## Architectural Review Board Staff Report

**Meeting Date: May 4, 2023**  
**Report #: 2304-1309**

PUBLIC HEARING / QUASI-JUDICIAL. 3001 El Camino Real [22PLN-00229]: Recommendation on Applicant's Request for Approval of a Major Architectural Review Application Allowing Demolition of Two Existing Retail Buildings to Construct a 129 Unit, 100% Affordable, Five-story, Multi-family Residential Rental Development Utilizing Allowances and Concessions Provided in Accordance with State Density Bonus Regulations. The Units Would be Deed Restricted to Serve Tenants Meeting 30%-50% of Area Median Income. The Project Would be Located on a 49,864 Square-Foot lot Located at 3001-3017 El Camino Real. Environmental Assessment: An Initial Study/Mitigated Negative Declaration Was Circulated for a 30-day Public Review Beginning on February 13, 2023 and Ending on March 15, 2023 in Accordance with the California Environmental Quality Act (CEQA). A Final MND is available for review. Zoning District: CS (Service Commercial). For More Information Contact the Project Planner Claire Raybould at [Claire.Raybould@cityofpaloalto.org](mailto:Claire.Raybould@cityofpaloalto.org)

Figure 1b  
Olive Avenue Site Access Travel Patterns

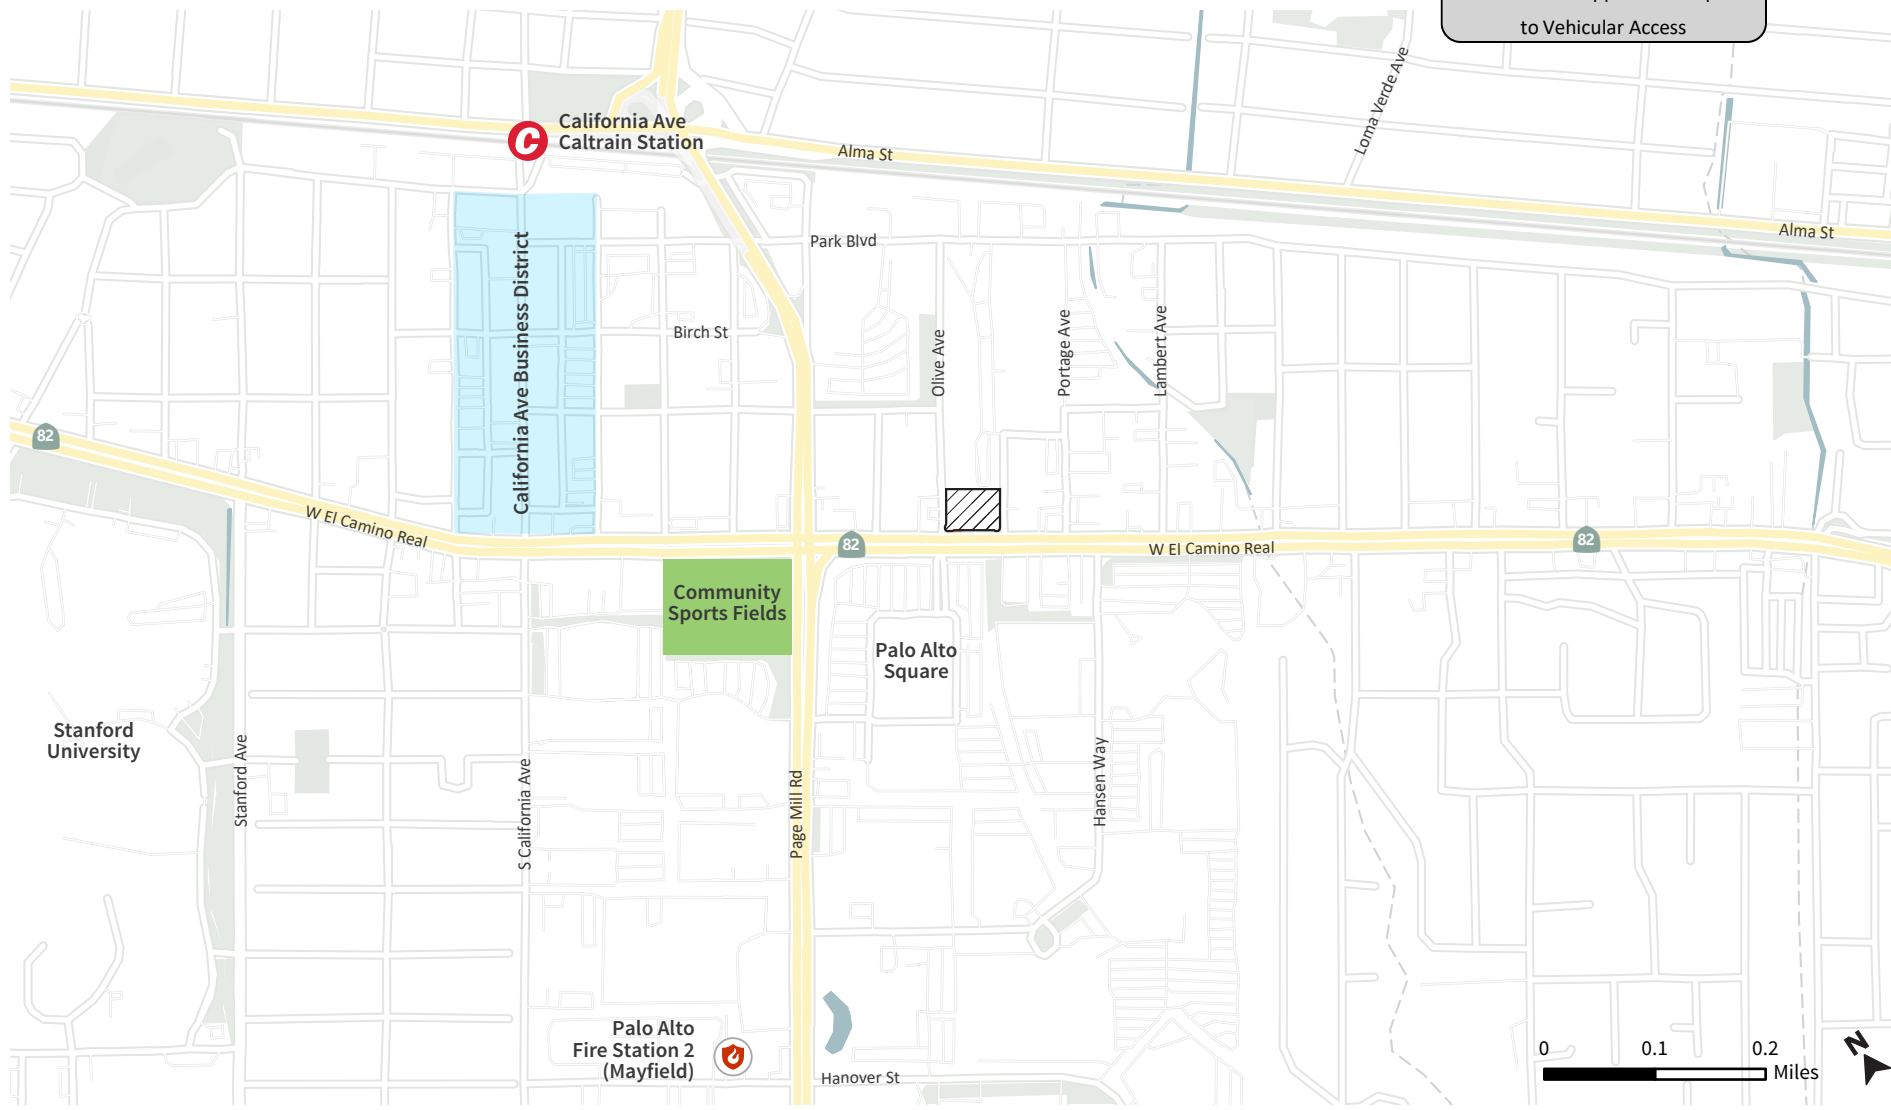
The applicant has not revised the location of the vehicular access. Additional information from the applicant (Attachment G) shows: the options for ingress and egress if access were provided from either Acacia or Olive Avenue, and a summary of the required turning movements under each scenario. No changes are planned for Olive Avenue, El Camino Real, or Acacia now or in the foreseeable future. Therefore, staff's analysis is based on the current conditions. The NVCAP will propose to make Ash Street a one-way southbound street in order to eliminate cut-through traffic from El Camino Real to Page Mill Road avoiding the right turn on Page Mill/Oregon Expressway. The only affect this will have on the project is that residents that may leave the site to head eastbound on Oregon Expressway would head to Park instead of Ash. This would result in roughly one additional vehicle trip every five minutes during the peak hour that would travel the full length of Olive instead of turning on Ash Street. But it will also reduce existing cut-through traffic on this street.

Under current and foreseeable future conditions, providing access from Olive Avenue would allow for northbound and southbound access to El Camino Real. A resident attempting to travel southbound on El Camino Real from Olive or Acacia would need to cross three lanes of traffic regardless of whether they do this to enter a turn pocket for a U-turn or turn left directly from Olive Avenue. As discussed in the previous staff report, the Office of Transportation has noted that either option could provide safe vehicular access to and from the site and it is not expected that either would result in a safety concern or an inconsistency with Council's Local Transportation Policy. However, the analysis was completed based on the proposed project. If the applicant were to redesign the project based on this comment, the City would require a revised transportation analysis to evaluate the Acacia/El Camino Real intersection as well as the queueing in the turn pocket on El Camino Real, to confirm these assumptions and show compliance with Council's policies related to local transportation impacts.
